RE: **Argonne St Residences Comment Responses**  
**Case Number: 2003-4008-04**

This letter is meant to address the comments received 6/4/2021.

SITE PLAN AMENDMENT

### ARGONNE STREET RESIDENCES

### **COMMENTS ON SHEET 5**

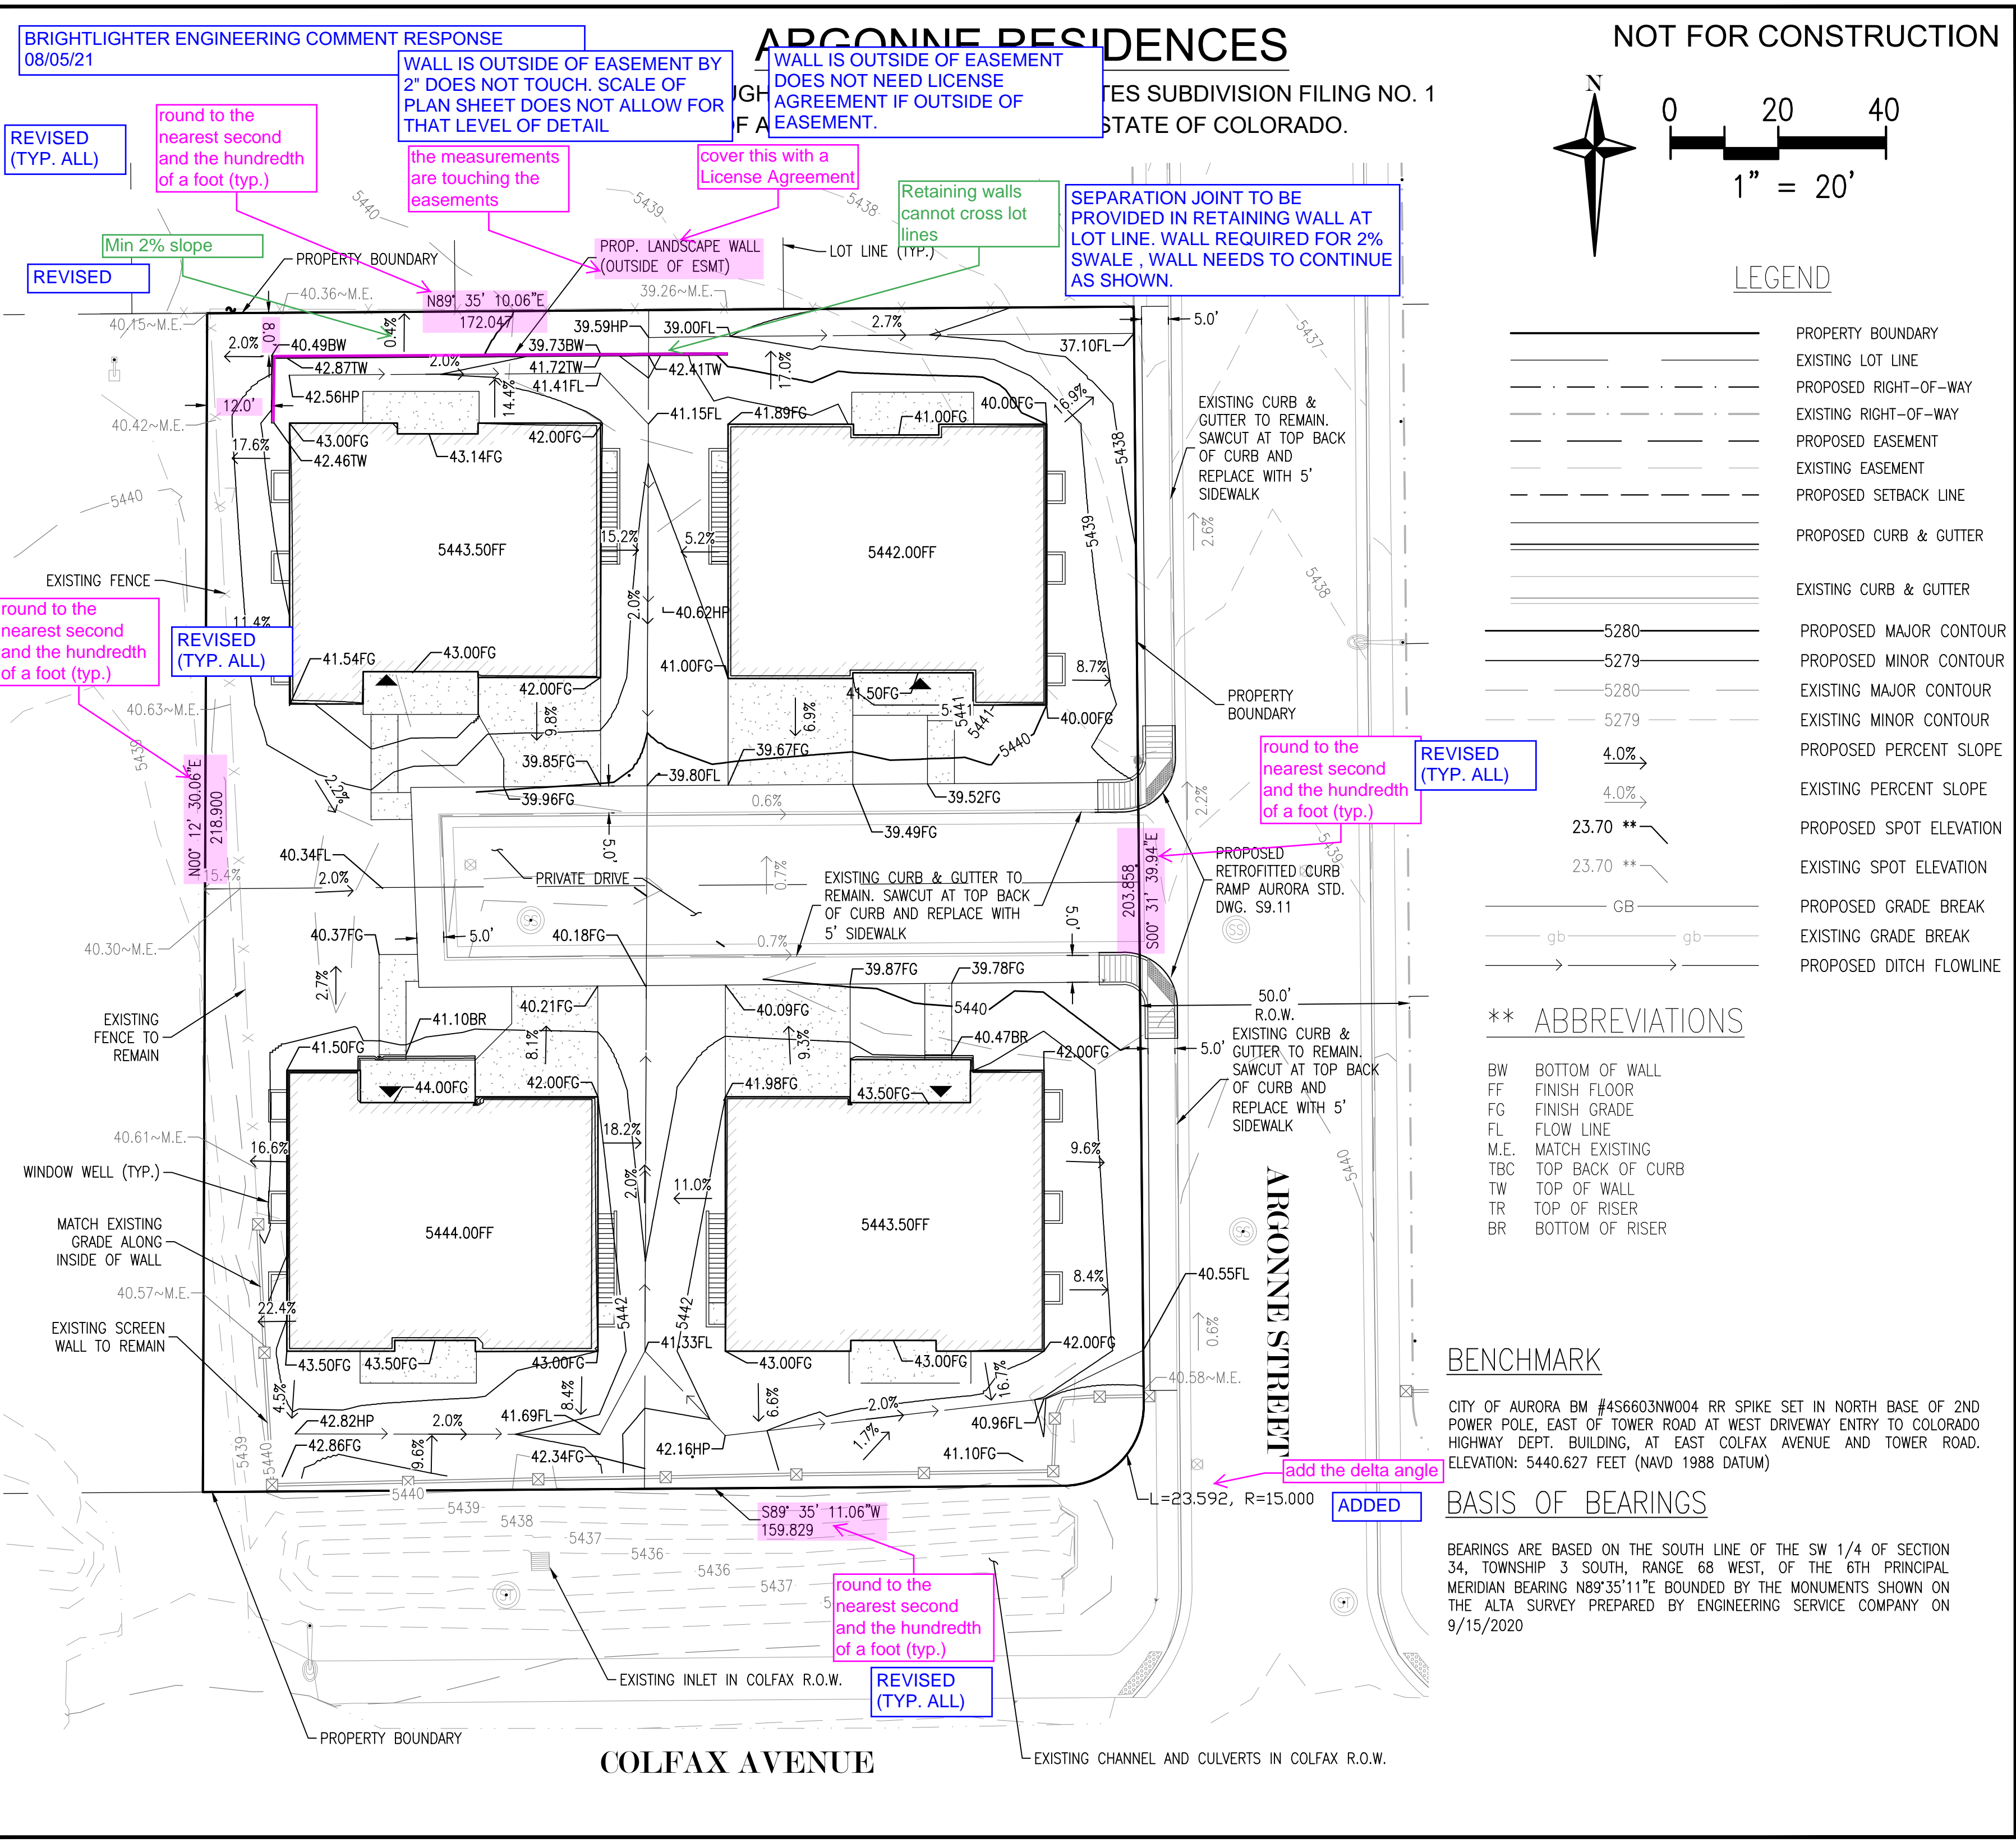
CITY COMMENT: *Update the plant schedule to reflect that all shrubs shall be five-gallon at time of installation and all perennials shall be one gallon.*

CITY COMMENT: *Update the City of Aurora Landscape Notes per the comment provided*

CITY COMMENT: *Update the requirements for the landscaping of front yards. Likely the plant material has been provided, but follow the requirements found in Table 4.7-3 and provide a table documenting compliance*

CITY COMMENT: *Remove as this refers to the previous landscape code.*

CITY COMMENT: *Because the front yards appear to be xeric, they likely qualify for the \$1,000 tap credit per lot. Contact Aurora, Water, Tim York (303) 326*

CITY COMMENT: *Lighten the color of the sod hatch.*

CITY COMMENT: *While the plant material provided the intersection of the street and Argonne Street meets code requirements, given its high visibility and location as the entrance to the development, it would be aesthetically more pleasing if both sides match with plant material.*

ODG RESPONSE: Plant schedule has been updated to reflect required sizes.

ODG RESPONSE: The note regarding landscaping in the sight triangle has been added to the "City of Aurora Landscape Notes" on sheet 5.

ODG RESPONSE: The "City of Aurora Landscape Requirements" table on sheet 5 has been updated to more clearly document the requirements of the city's Table 4.7.3.

ODG RESPONSE: The text this comment refers to (under Line 3 of the "City of Aurora Landscape Notes" on sheet 5) has been removed.

ODG RESPONSE: Comment noted.

ODG RESPONSE: The hatch indicating sod has been lightened on the plan.

ODG RESPONSE: The landscaping at the corners of the intersection has been changed to match both sides.

GRADING  
PLAN

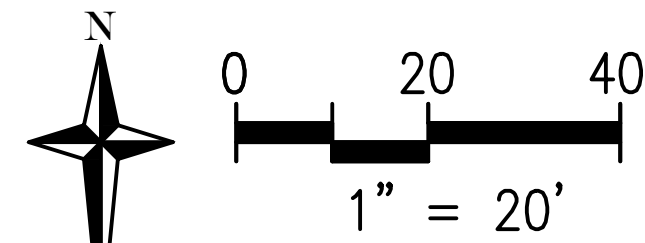
round to the nearest second and the hundredth of a foot (typ.)

the measurements are touching the easements

cover this with a License Agreement

Retaining walls cannot cross lot lines

round to the nearest second and the hundredth of a foot (typ.)

round to the nearest second and the hundredth of a foot (typ.)

add the delta angle

round to the nearest second and the hundredth of a foot (typ.)

WALL IS OUTSIDE OF EASEMENT BY 2" DOES NOT TOUCH. SCALE OF PLAN SHEET DOES NOT ALLOW FOR THAT LEVEL OF DETAIL

WALL IS OUTSIDE OF EASEMENT DOES NOT NEED LICENSE AGREEMENT IF OUTSIDE OF EASEMENT.

REVISED (TYP. ALL)

SEPARATION JOINT TO BE PROVIDED IN RETAINING WALL AT LOT LINE. WALL REQUIRED FOR 2% SWALE, WALL NEEDS TO CONTINUE AS SHOWN.

REVISED (TYP. ALL)

REVISED (TYP. ALL)

ADDED

## UTILITY PLAN

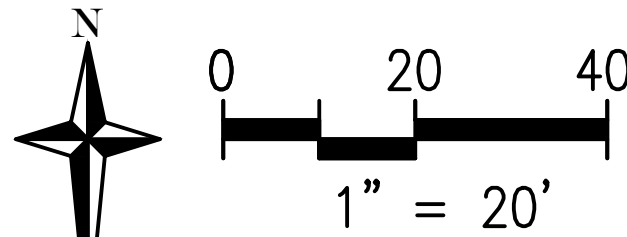
Show the proposed street light as shown on the site plan. If a lighting study is conducted that shows the existing conditions meet current lighting standards, a new light would not be required.

ADDED
